Oakton College District 535

Invitation to Bid # 0925-24-03 -Addendum #1
Issue Date: September 25, 2024

Oakton College Des Plaines Adjacencies Renovations - Phase 1

2.) Provide the updated drawing and Project Manual, including responses to the questions submitted by vendors.

E04-01

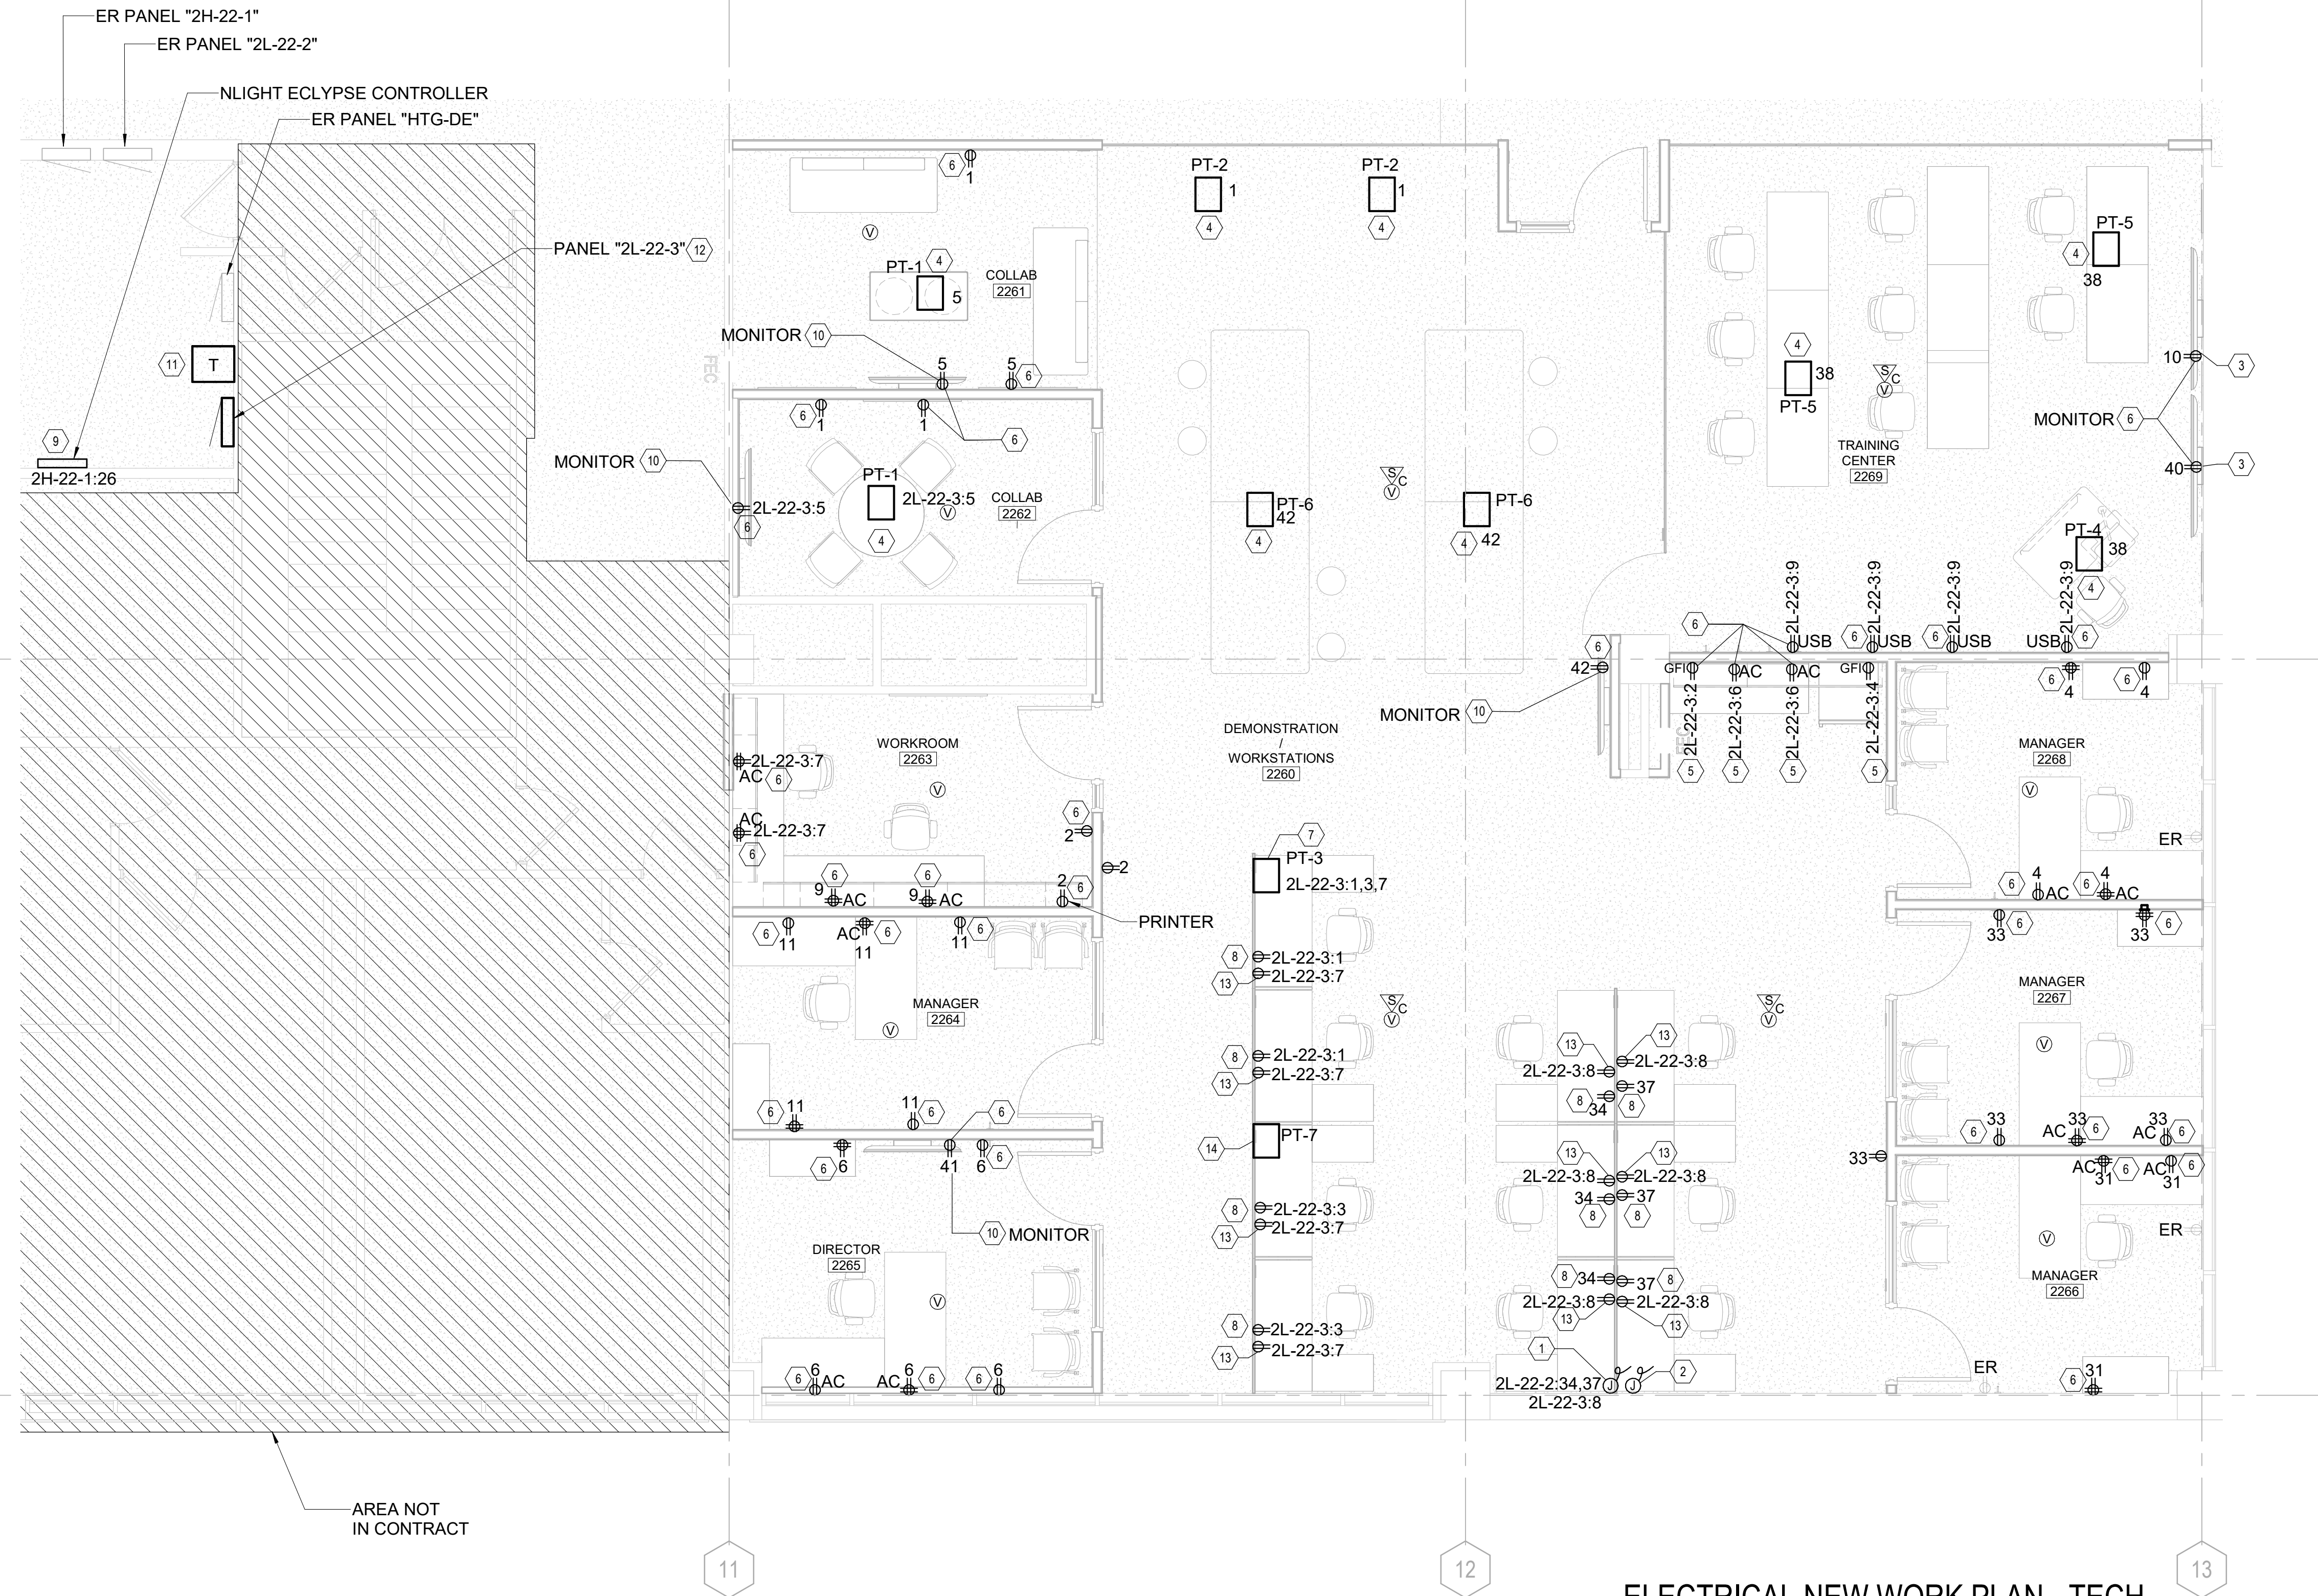
- 1) Revised mechanical installation Note 7. Added relocated VAV equipment data and balance point.
4. Electrical:
 - a. Sheet E04-01 Electrical Demolition Plans – Phase 1

- 1) Revised electrical keyed note 2
 - b. Sheet E10-01 Electrical New Work Plan – Phase 1 – Tech Hub
 - 1) Revised electrical keyed notes 4, 7, & 14

12. There are some existing floor outlets in the slab on grade and 2nd floor slab on deck that are to be removed. Is there a concrete infill detail we should follow? Please clarify.

A: Refer to revised keyed note on sheet E04-01.
